(A) CORRIGENDUM- Tender No- 310/2020/1446

Modification in Tender Documents already hosted by SIDBI in respect of Tender No- 310/2020/1446 seeking invitation of offers for acquiring office premises on Leave and License basis at Haridwar, Uttarakhand

**CORRIGENDUM / ADDENDUM TO TENDER DOCUMENT– OFFICE PREMISES HARIDWAR DATED
09/04/2019**

Network Cabling Diagram (for illustration purpose only)

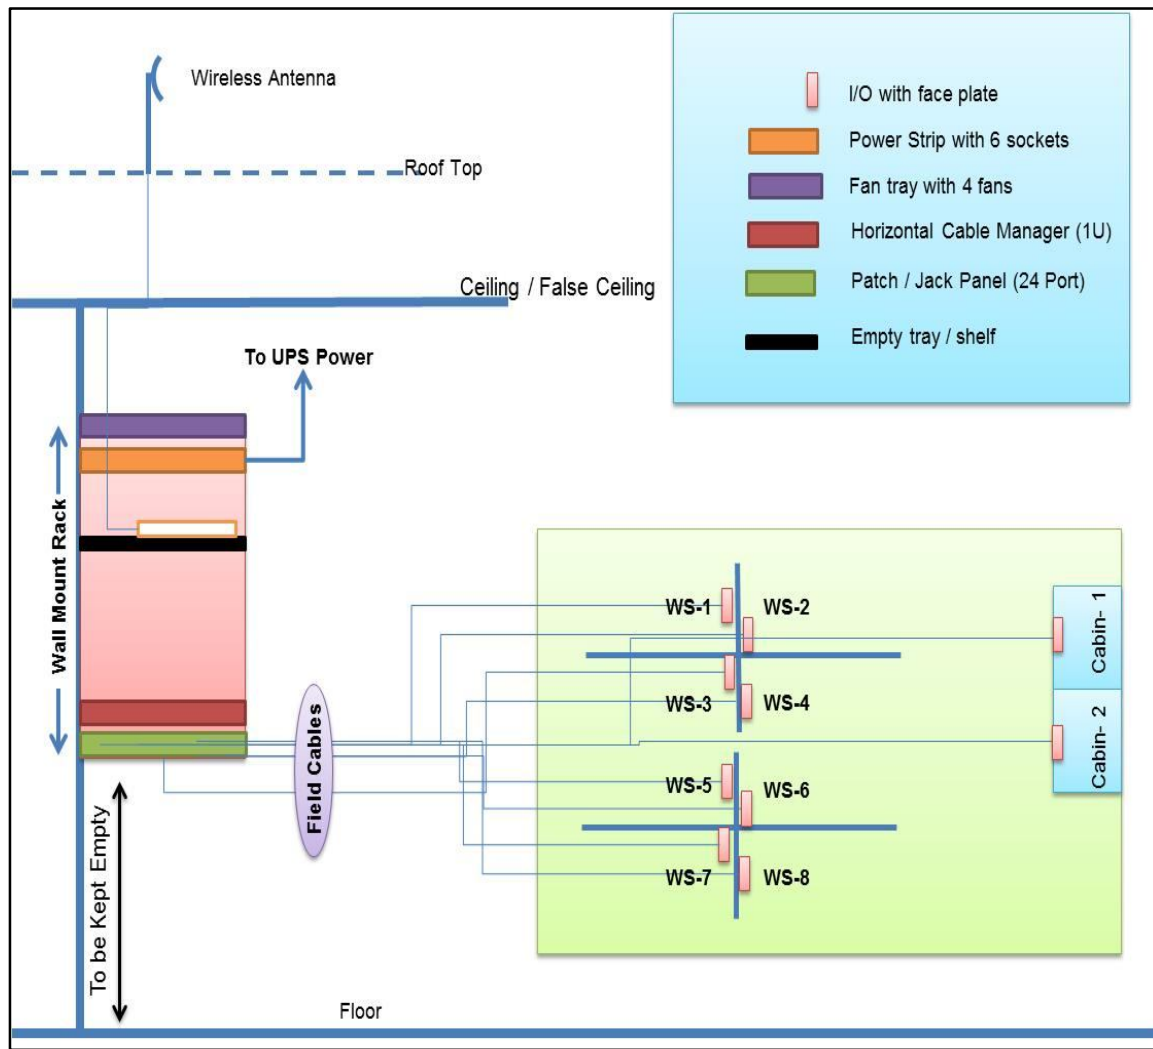
Sr No	As per tender Document hosted	Revised																		
17	<p>17. LAN Cabling -From UPS / Switch room to all the workstations / seats LAN cabling</p> <p>with CAT - 6 approved make cable to be provided in PVC conduit alongwith suitable modular type outlet boxes and RJ-45 connectors</p>	<p>17. LAN Cabling – The LAN cabling to be provided should be structured with the following components installed:</p> <p><u>a). Network Rack (Metal)</u></p> <p><u>(i) Specifications / Requirements of Rack and Patch cords</u></p>

6	Power Strip with 6 / 8 three pin Indian Sockets	One
		7	Fixed Shelves / trays	One
		8	CAT 6 Patch / Jack Panel of 24 ports and 1U size	One
		9	Horizontal Cable Manager of size 1U	One
		10	Factory Crimped 7 feet CAT 6 patch cord	15
		11	Factory Crimped 3 feet CAT 6 patch cord	15
<p>(ii). The rack would be installed at a location where there is air conditioning. In case of floor mounting rack, the space above the rack till the ceiling / false ceiling should be kept open for future requirements / expansions and in case of wall mount rack, the space below the rack should be kept open for future requirements / expansions.</p> <p><u>(b). Cabling</u></p> <p>(i). Surface mount Information Outlet (I/O) boxes with connectors affixed to the partition along with face plate one each at each workstation/ cubical/ cabin/ conference room and for printers.</p> <p>(ii). All field cables originating from workstation / cubical/cabin/conference room/printer should be terminated / crimped to the patch / jack panels. Numbering of cables at both ends and on patch/jack panel to be carried out.</p> <p>(iii). All field cables within the bank premises should be laid through PVC conduit along a duct.</p> <p>(iv). All ports on patch panel, I/O and cables should be properly tagged for easy identification. Complete LAN diagram to be provided.</p>

<p>(v). All cables and passive components (I/O, patch/jack panel etc for LAN connectivity should be CAT 6 only.</p> <p>(vi). Total Number of Network Points - 15</p> <p>c). For illustration purpose structured cabling diagram is given in Appendix –ii.</p>
--	--	--
